South Texas Project Electric Generating Station 4000 Avenue F - Suite A Bay City, Texas 77414

July 15, 2008
ABR-AE-08000052

South Texas Project
Units 3 and 4
Docket Nos. 52-012 and 52-013
Response to Requests for Additional Information

Figure 1- Comparison of TWDB and USGS reported total groundwater withdrawals for Matagorda County from 1980 through 2005.

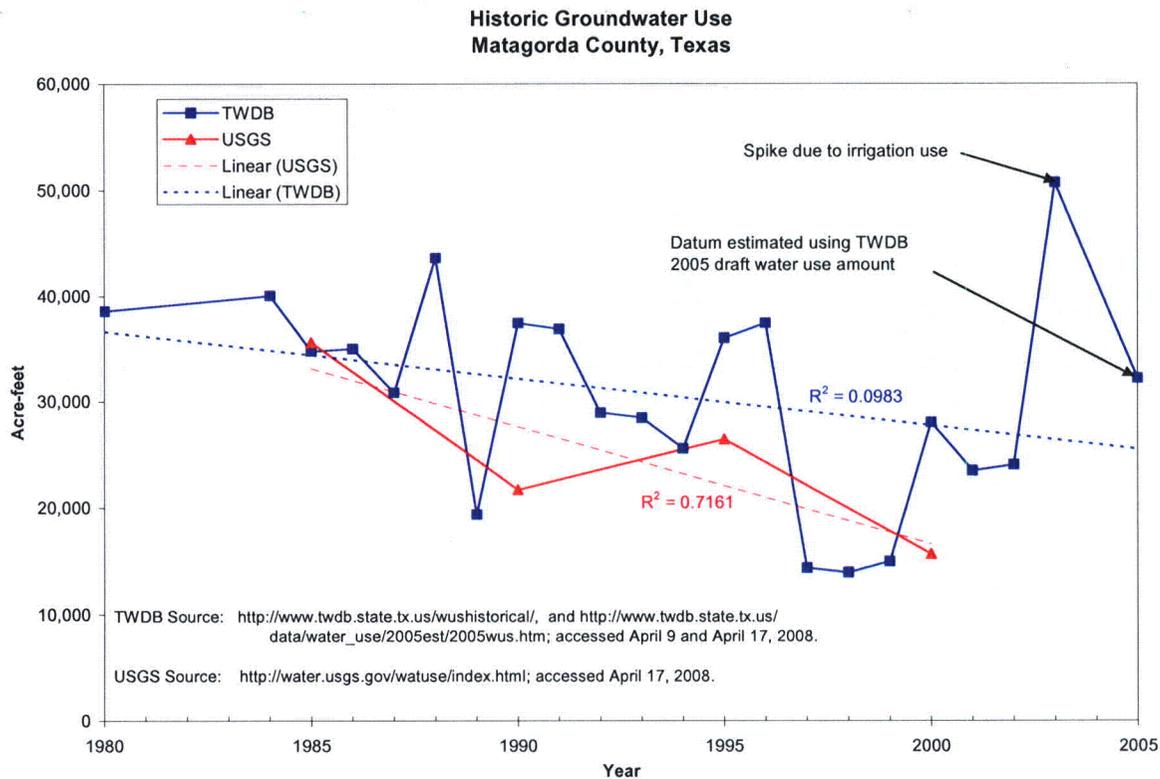
(1) Provide a summary discussion of the underlying rationale for the substantial decline in groundwater consumption in Matagorda County (~50%) by 2030 forecasted by the State of Texas in 1985 (e.g., movement from groundwater to surface water sources because of salt or brackish water intrusion, an observed and marked decline in groundwater quality). Has salt or brackish water intrusion been observed, evaluated, or forecasted for the Chicot aquifer? Since the 1985 forecast, how has groundwater resource utilization changed? Has the forecast become reality? Based on the NRC's initial independent evaluation, in discussions with the Coastal Plain Groundwater Conservation District (CPGWCD) during the ER Site Audit in February 2008, the 1985 forecast does not appear to have materialized and that portraying groundwater usage in Matagorda County in this light may not be current despite the availability of a State authored reference. Provide a discussion to reconcile these views.

(2) Provide a projection of future groundwater use in Section 2.3.2.2 that could affect or be affected by the construction or operation of the proposed project. The current discussion is limited to current or present-day usage. Table 2.3.2-6 provides the water demand for the Lower Colorado River Region; however, it appears to represent the combined surface water and groundwater demand. If the table reflects the combined demand, then provide a breakdown of the water demand described in Table 2.3.2-6 between surface water and groundwater resources.

Because separate groundwater demand projections for Matagorda County are not available, groundwater utilization for Matagorda County was estimated in the FSAR using projected water use from the Lower Colorado Regional Water Planning Group (LCRWPG) Water Plan and historic uses from the TWDB. To provide further insight to how the groundwater utilization may have changed since the forecast presented by TDWR in 1985, the data collected by the USGS regarding historic groundwater use in Matagorda County were also used to provide a “separation” of groundwater from the TWDB-approved water demand projection data.

Based on the individual water use group projections detailed in FSAR Section 2.4S.12.2.1, summarized in Table 2.4S.12-6 and illustrated in Figure 2.4S.12-14, a groundwater use projection for Matagorda County for 2060 is estimated to be about 42,000 acre-feet. Using the USGS historic groundwater use data, a similar projection is estimated to be about 32,500 acre-feet. The contrast illustrates the problem of dealing with the combined projected water uses provided by the TWDB. However, both of these estimates are below the estimated groundwater availability amount of 49,221 acre-feet for Matagorda County (Turner Collie & Braden, Inc., 2004).

Figure 2.5-23. Palacios Revenues by Source, 2007 Total Revenues: \$1.8 Million

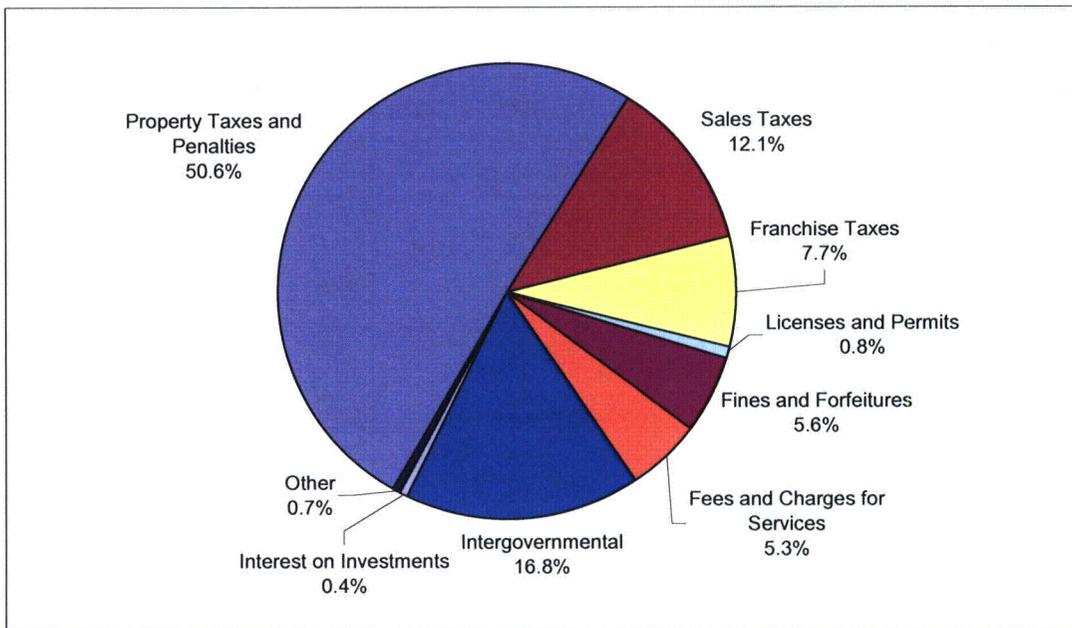
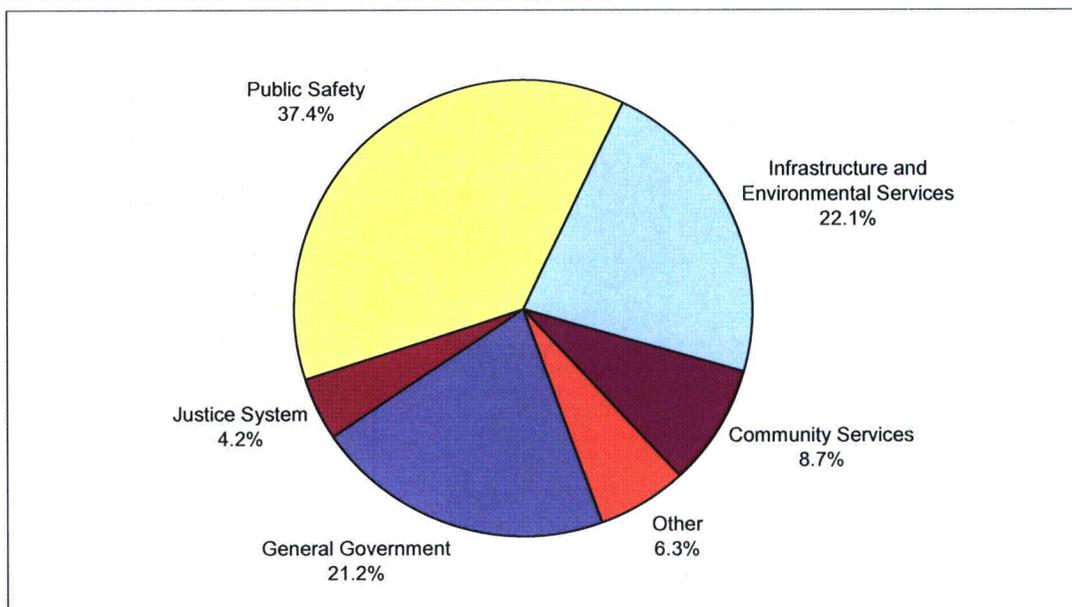
Provide revenue and expenditure data for the City of Palacios.

Data are available on revenues and expenditures in the City of Palacios. The paragraph, tables, and figures shown below will be included in the revised draft of ER 2.5.2.

Unlike Bay City, the City of Palacios receives approximately half of its revenues from property taxes, accounting for 50.6% of 2007's total revenues of \$1.8 million. The Palacios proposed budget for 2008 showed a 31.4% increase in property tax revenues over the adopted budget for 2007. In Palacios, whose population as of the 2000 Census was roughly one-fourth the size of Bay City's (Reference 2.5-3), sales taxes accounted for only 12.1% of total revenues, reflecting the much smaller retail sector. Table 2.5-43 and Figure 2.5-23 illustrate Palacios revenues by source. Total budgeted expenditures in Palacios for 2007 were nearly \$2.2 million, with 37.4% spent on public safety, 21.2% on general government, and 22.1% on Infrastructure and Environmental Services. Expenditures by category are summarized in Table 2.5-44 and shown in Figure 2.5-24.
